Docket Number:	15-AFC-01
Project Title:	Puente Power Project
TN #:	206310
Document Title:	Applicant's Responses to City of Oxnard Data Requests, Set 2 (47-67)
Description:	N/A
Filer:	Paul Kihm
Organization:	Latham & Watkins LLP
Submitter Role:	Applicant Representative
Submission Date:	10/8/2015 4:29:47 PM
Docketed Date:	10/8/2015

Puente Power Project (P3)
Oxnard, CA

**Responses to City of Oxnard
Data Requests Set 2 (47-67)**

FIGURE 56-1

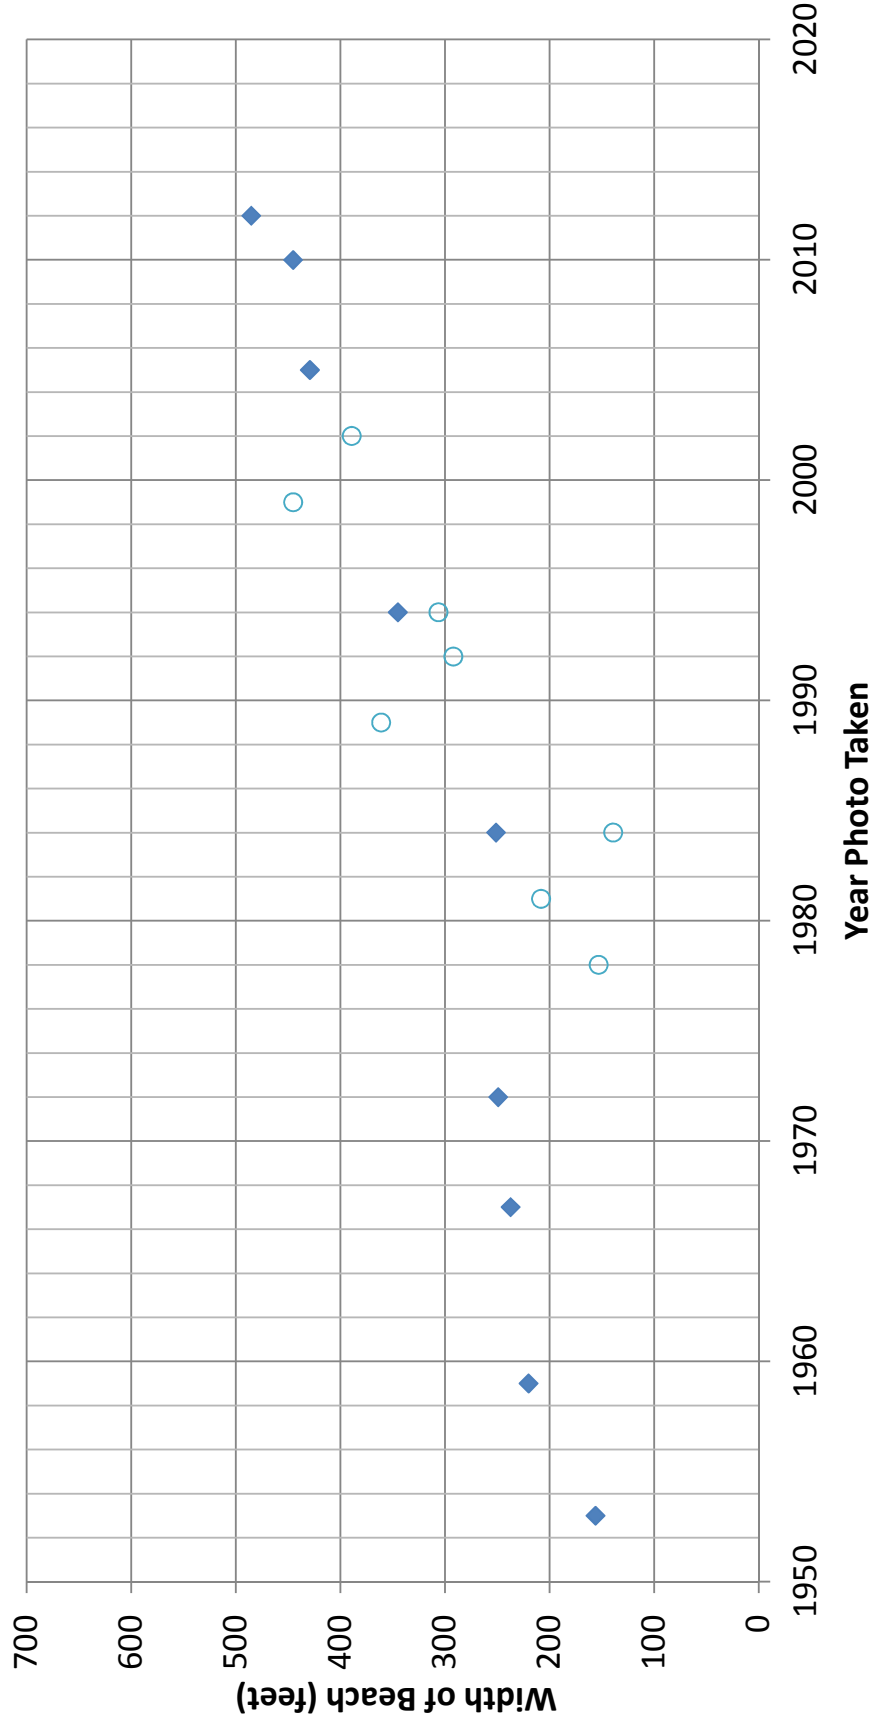
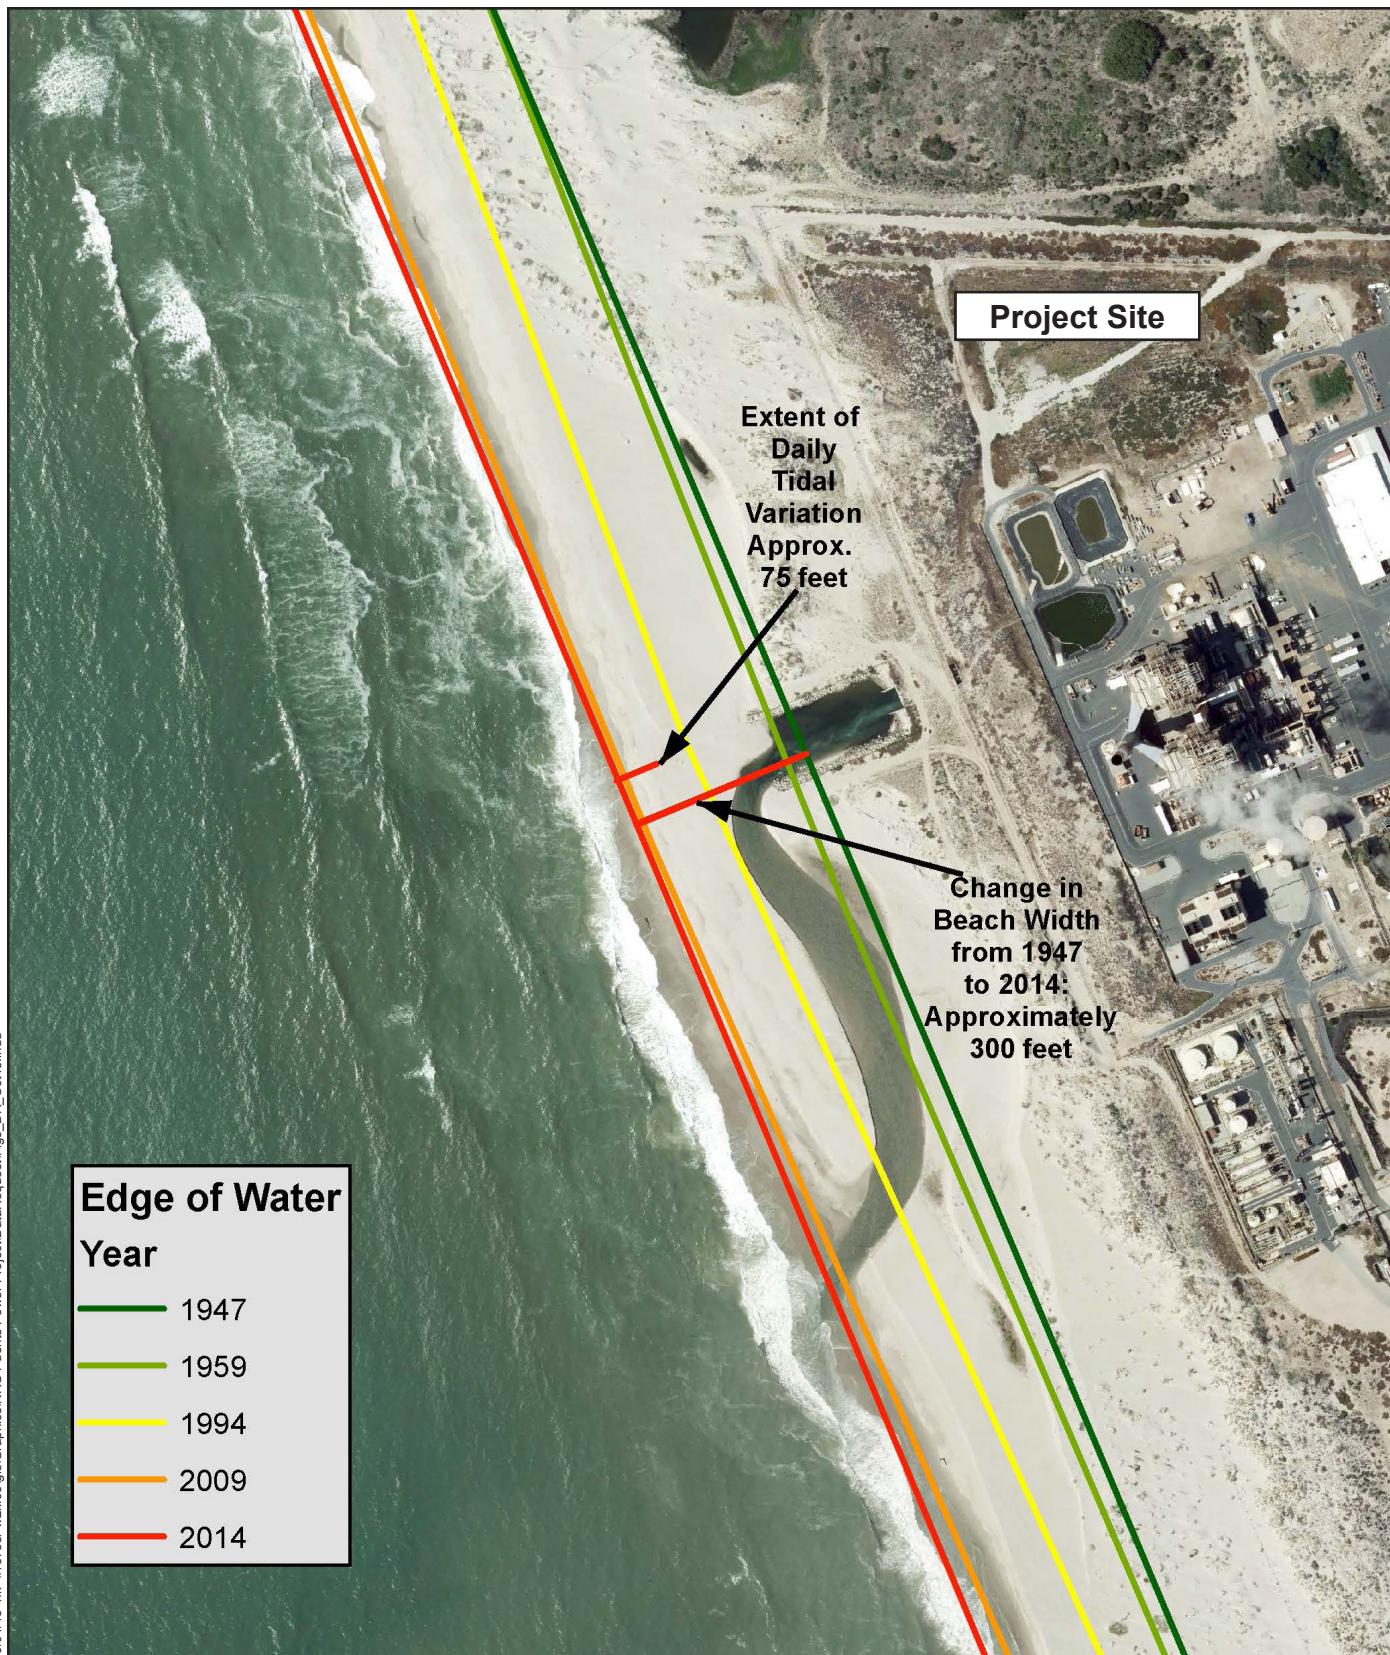
- 56. Please provide any analysis conducted by NRG or its consultants of the effect that the dredging of Ventura Harbor has on the accretion and/or erosion of the beach that abuts the Mandalay Bay Generating Station.**

Figure 56-1 shows the change in beach width over time based on an analysis of aerial photographs. Figure 56-2 shows changes in beach width over time by overlaying the water lines from the photographs relative to each other. Note that there is little change in width in the early photos (indicated by a “clumping” of lines near the MGS outfall structure), then an increase in width of about 400 to 500 feet from the outfall which remains relatively constant for approximately the last 10 years.
